AUSTRALIAN PARACHUTE FEDERATION

RISER FAILURE

MANDATORY INSPECTION in accordance with APF Service Bulletin **APF010801-B* Issued 23rd January 2009** of **all 3-ring riser assemblies before the next jump**. Inspection to be noted on reserve packing card and marked on inside of front riser with APF010801-B using a fine tip paint pen so it will be visible even if the risers are black.

Typical view of locking loop length

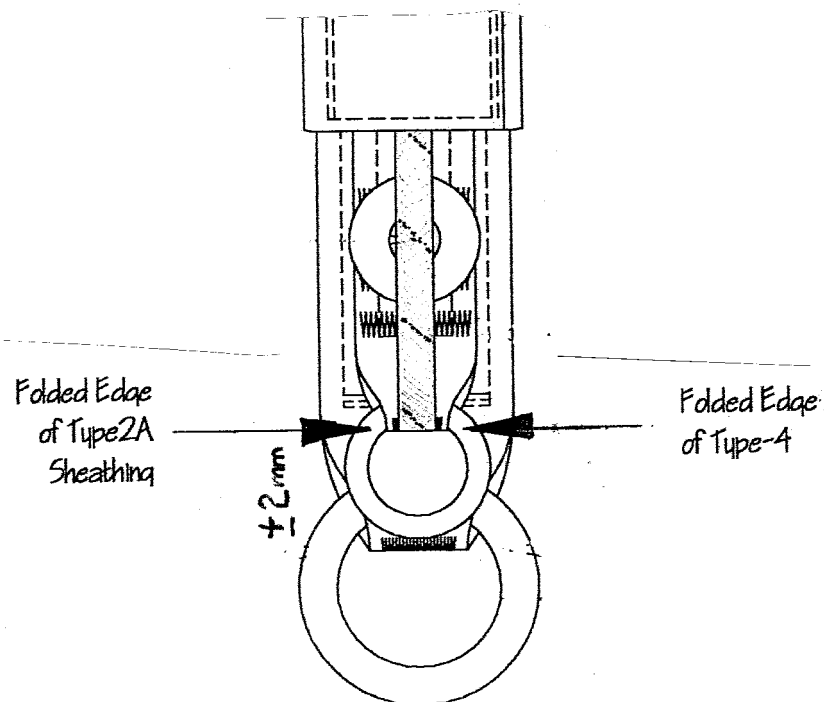
In August 2001 the APF promulgated APF Service Bulletin No APF010801-A 3-ring Inspection And Maintenance. The inspection, Part A, is designated **Mandatory**. This rig's reserve had been packed six times since the service bulletin was published, and numerous other times when the main was packed and possibly the 3-rings serviced. Had the service bulletin been applied it would have highlighted that the riser did not meet the criteria of the service bulletin as **the locking loop was too short**.

Due to the unique method of construction on this riser of bar-tacking across the loop it is probable that over a period of jumps some of the stitches had broken due to the excessive load applied by the short locking loop until on this jump they failed completely allowing the loop to pull out of the riser, releasing it. It is impossible to visually inspect the stitching as it is covered by the confluence wrap, failure comes without warning signs. There was no kink in the left cutaway cable to warn of excessive loading. To prevent a similar event occurring especially when an RSL is fitted the following must occur.

On all solo rigs and all types of riser style, one inch type 17 mini rings, type 8 mini rings and standard type 8 with the larger rings, the length of the locking loop should be level (+/- 2mm) with the end of the fold of the webbing that retains the small ring when the riser is laid flat with some tension applied to the small ring.

It is normal for new type 17 mini risers to be tight to interlock the rings, this is because they become more pliable with use, but the locking loop must still allow the housing some play and not pull the small ring against the riser, see side view on service bulletin.

**This Service Bulletin replaces APF SB 010801-A Issued August 2001. New inclusions:
Identification of personnel to conduct inspection and required method to record inspection.*
